July 8, 2003
NRC-03-0053

Subject: Response to NRC Request for Additional Information
Regarding the Implementation of Alternative Source Term

**FERMI 2 NRC DOCKET NO. 50-341
OPERATING LICENSE NO. NPF-43**

**RESPONSE TO NRC REQUEST FOR ADDITIONAL INFORMATION
REGARDING THE IMPLEMENTATION OF ALTERNATIVE SOURCE TERM**

Attachment 1 - Assessment of Steam Line Temperatures for Piping Deposition Credit Analysis

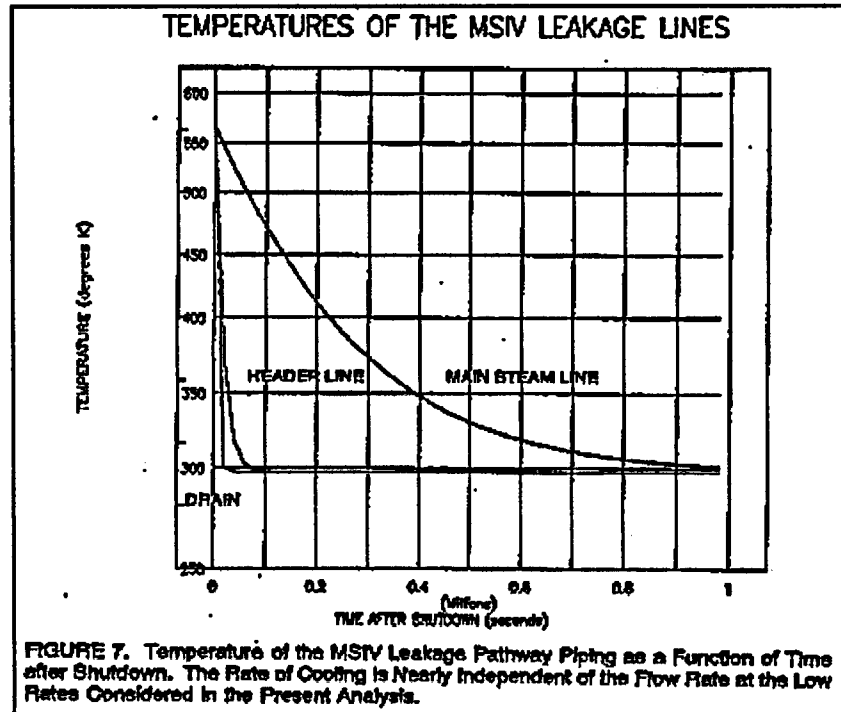
6. For each main steam pipe segment for which you are applying the Brockman-Bixler model, please provide the time dependent values for the following parameters:
 - 6a. Gas pressure
 - 6b. Gas temperature
 - 6c. Pipe volume
 - 6d. Pipe inner surface area

Steam piping temperature derivations are shown in Attachment 1 below. As noted in the Attachment, only heat removal by conduction is considered. This maximizes piping temperatures; therefore, it is conservative for purposes of piping deposition credit.

Main steam line wall temperatures following a LOCA have not been calculated specifically for Fermi. A generic cooldown analysis developed by GE and reported in August 1990 Cline Report (Reference 1) is used. Cooling is considered independent of leakage flow. Only conduction is considered. The function to the right is from Reference 1 and fits the figure below (from Reference 2) and is used for Fermi:

$$T(^{\circ}K) = 299.7 + 265.6 * e^{04.428 * 10^{-6} t}$$
